SR-2 – ADVISORY STAFF REPORT (03-06-2026)

ADDRESS: 1965 ORLEANS

APPLICATION NUMBER: HDC2026-00023

SCOPE: REPLACE ALUMINUM WINDOW SYSTEMS WITH FIBREX WINDOW SYSTEMS

Staff photo, 02-24-2026. Northeast elevation.

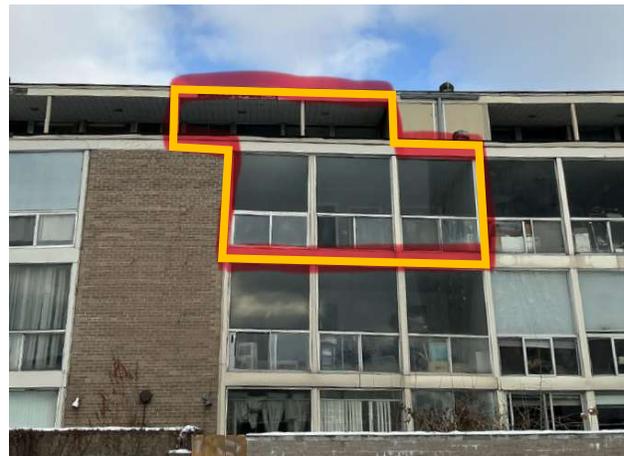
- The applicant states “The building currently retains its original window units, which are aluminum-framed, early-generation double-pane glass panels installed during original construction circa 1966. While these windows were once modern in appearance and functional for their time, they now exhibit signs of significant wear, energy inefficiency, and safety concerns.” They also provide the following descriptions of the existing conditions:

- *Structural and Operational Deterioration: Many of the current windows have rusting or pitted frames, compromised locking mechanisms, and non-functional sashes, creating not only aesthetic issues but also safety and egress concerns.*

- *Moisture Infiltration: Several units have reported water penetration at the window perimeters, creating risks of mold, interior damage, and long-term structural decay.*

- Although the existing aluminum window systems are distinctive and historic character-defining features, considering the amount of deterioration and the lack of individualized components causing the inability to complete repairs, it is staff's opinion that the existing historic aluminum window systems are beyond reasonable repair.

2011 ORLEANS

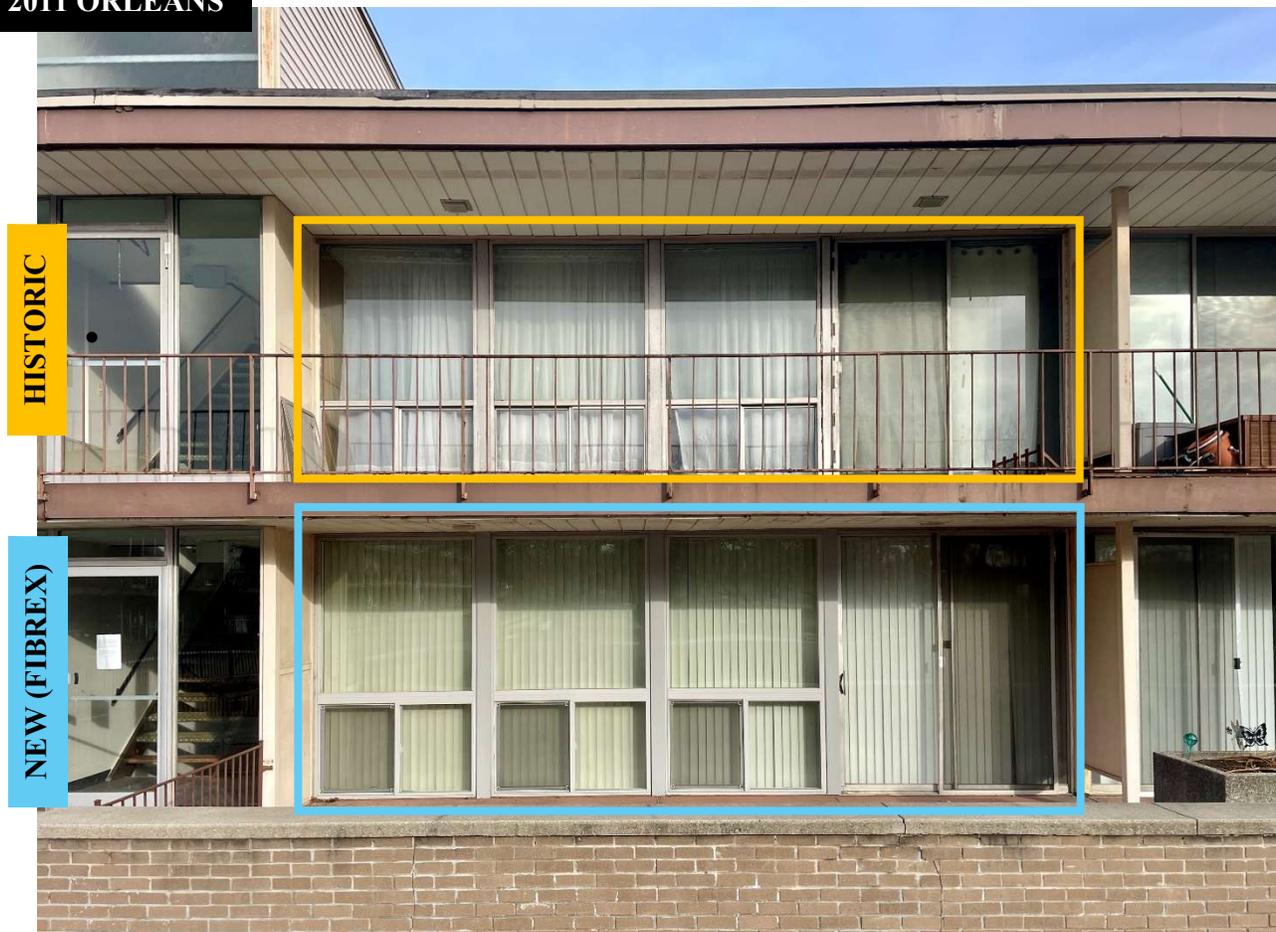
- Units in the same complex, 2011 Orleans (HDC2025-00461) and 2025 Orleans (HDC2025-000464), received a Certificate of Appropriateness (COA) from the Commission at the 10-08-2025 meeting for the same scope of work and product. 2011 Orleans installed their new Andersen 100 Series / Fibrex window systems, as shown below.

- It is staff’s opinion that the replacement window systems are appropriate, since they match the historic windows in design, operation, color, and other visual qualities, as demonstrated by the installation at 2011 Orleans.
